Department of Energy
National Nuclear Security Administration
Washington, DC 20585

Subject: Laboratory Response to DNFSB Letter Regarding Pu-238 Scrap Recovery Line

**LANL Response to DNFSB Letter
Regarding Pu-238 Scrap Recovery Line**

Identification of Implicit Issues and OLASO Responses

Fig. 10. Correspondence between absorbed gamma dose and years of normal operations at TA-55.

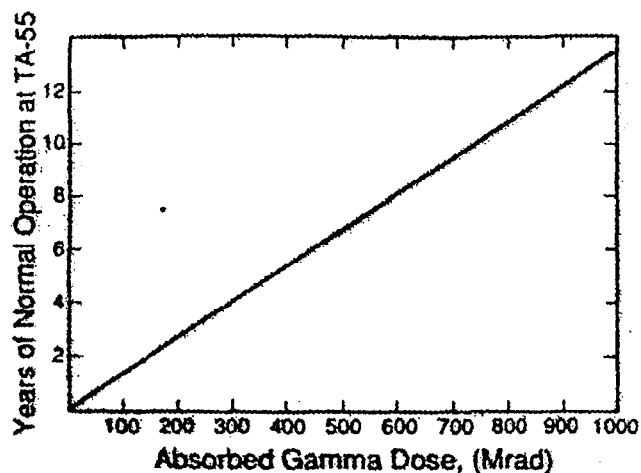
2. **Resin Accidents**—There are two principle examples of the incomplete analysis of scenarios related to anion exchange column accidents:
 - A. As a condition of approval, DOE required that prevention of resin dry out be treated as a safety-class control. However, LANL has not identified safety-class controls that would be effective in the event of a facility power failure and subsequent building evacuation. The anion exchange columns have an autoelution system, powered by an uninterruptible power supply, that might serve this function. It may be appropriate to evaluate this as a potential designated safety system and thereby ensure its reliability.

With regard to the DNFSB Staff Issue Report² concern relative to the resin dryout issue during a facility power failure and subsequent building evacuation, the DOE approval memo⁵ referenced a report entitled *The Effects of Ionizing Radiation on Reillex™ HPQ, a New Macroporous polyvinylpyridine resin, and on Four Conventional Polystyrene Anion Exchange Resins*, LA-11912, November 1990, by S. Frederic Marsh.¹⁵ To assist in clarifying this issue, an excerpt from the report is reproduced here.

As shown in Fig. 10, an absorbed dose of 370 megarads corresponds to about 5 years of normal plutonium-processing operations at the Los Alamos Plutonium Facility (TA-55), which would indicate that the threshold for the observed thermal instability of Reillex™ HPQ resin could occur only after 5 years of routine operation at TA-55. (The Los Alamos Plutonium Facility, which operates a single shift five days per week and stores ion exchange columns in 1 M nitric acid between shifts, should not be used to estimate resin lifetime elsewhere.) Because resin damage from alpha particles is lower by at least a factor of two (see the following Alpha-Particle Irradiations section), however, the threshold for the cited thermal instability of Reillex™ HPQ resin actually corresponds to more than ten years of normal operations in the Los Alamos Plutonium Facility.

The combination of two factors—the improbability of resin becoming dried and heated during production operations and the required induction period of greater than 10 years at Los Alamos—virtually eliminates any possibility that thermal instability could occur in a production environment. Nevertheless, we recommend that Reillex™ HPQ resin be replaced after not more than 5 years of service, or 700 megarads of alpha-particle irradiation, or 400 megarads of absorbed gamma dose.
